## STAFF REPORT

### Site Plan & Architectural Review

**HEARING BODY:** Planning Commission  
**DATE & TIME:** **November 10, 2015 at 6:00 p.m.**  
**LOCATION:** City Council Chambers, City Hall, 500 Central Avenue, Coos Bay  
**APPLICANT:** Richard J. Ward, Richard Ward Associates,  
1312 Foster Way, Grants Pass, Oregon  
**OWNER:** Southwest Oregon IPA, Inc.,  
971 Commercial Avenue, Coos Bay, Oregon  
**LOCATION:** 281 LaClair Street, Coos Bay, Oregon  
T. 25S, R. 13W, S. 21BC, Tax Lot 100  
**SUBJECT:** **Site Plan and Architectural Review (SPAR) #187-ZON15-036 for the construction of an office and medical clinic campus**

FRONT ELEVATION

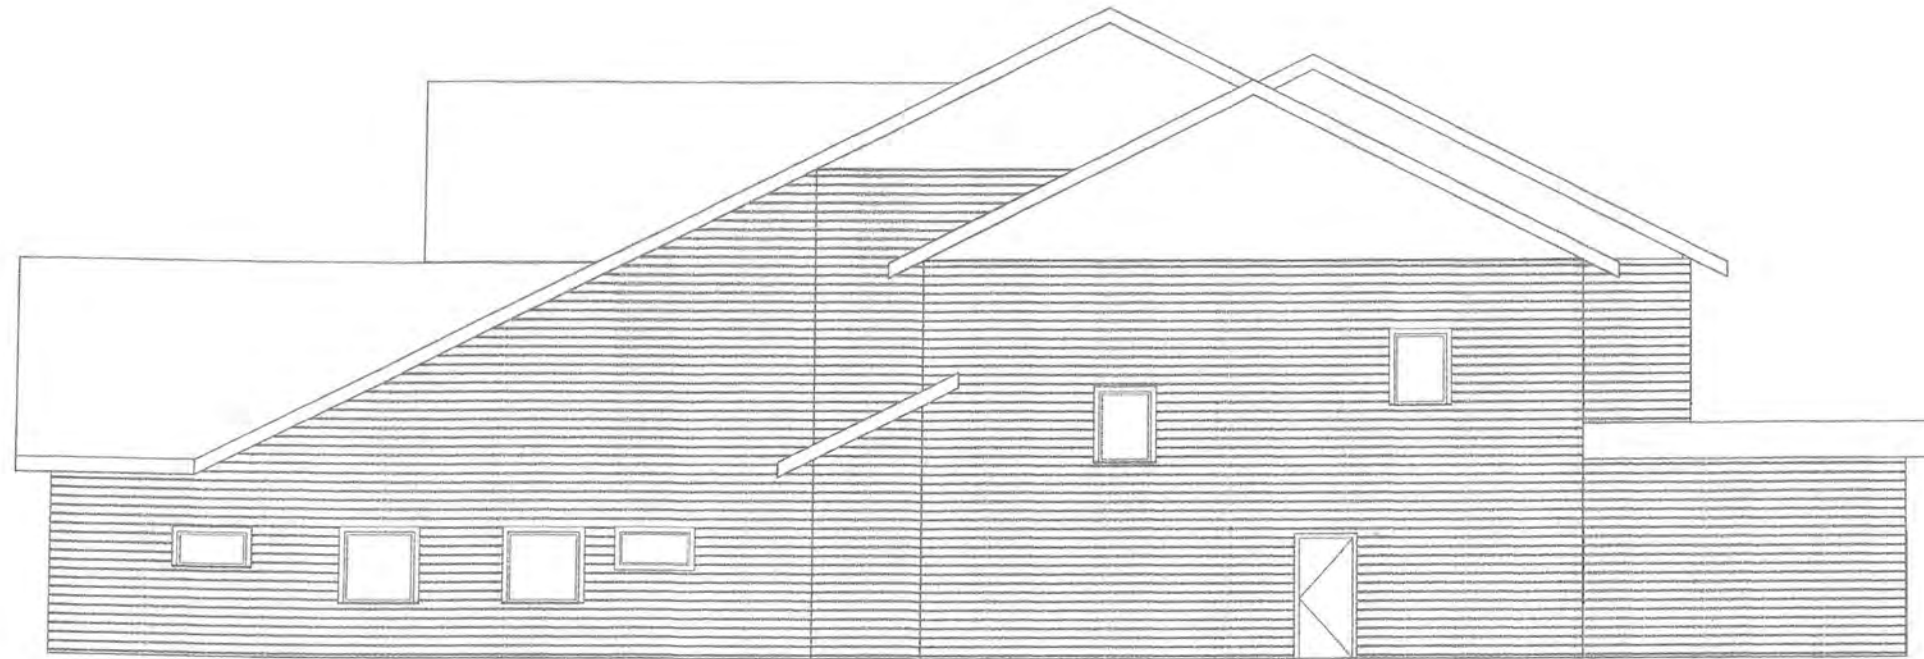
- 1c. The applicant's narrative suggests that the submitted building elevations and renderings of the two structures will be of a complimentary design and style with the two buildings on the Oregon Coast Community Action (OCCA) campus buildings that have been constructed immediately north of the subject site. However, more detail needs to be included into the buildings proposed on the WOAHP campus to ensure that they create better visual definition and aesthetic relief. This can be achieved by providing higher quality visuals of the proposed building designs in order that staff can be assured that the new campus buildings will add value to the community through compatible design. Adequate structural and architectural details to determine this were lacking with the initial application submittal.

The visual impacts need to be better presented in order to assure that the architectural elements of the SPAR are addressed in an appropriate manner. This portion of the decision criteria can only be adequately attended to and supported with a condition that clearly states that, through re-submitting of high-resolution architectural renderings and a quality of design which the applicant has committed to in the submitted narrative, such building profiles shall be accepted, reviewed, and approved by staff.

17. A revised set of building renderings and elevations shall be submitted that more clearly illustrate four-sided architectural details, articulation, forms, and profiles. Highlights of windows and other embellishments such as texture variation or use of deviations in color scheming or directional arrangement of exterior materials shall be provided that matches or equals the design techniques used for the CFRC building on the campus to the north of the subject property.
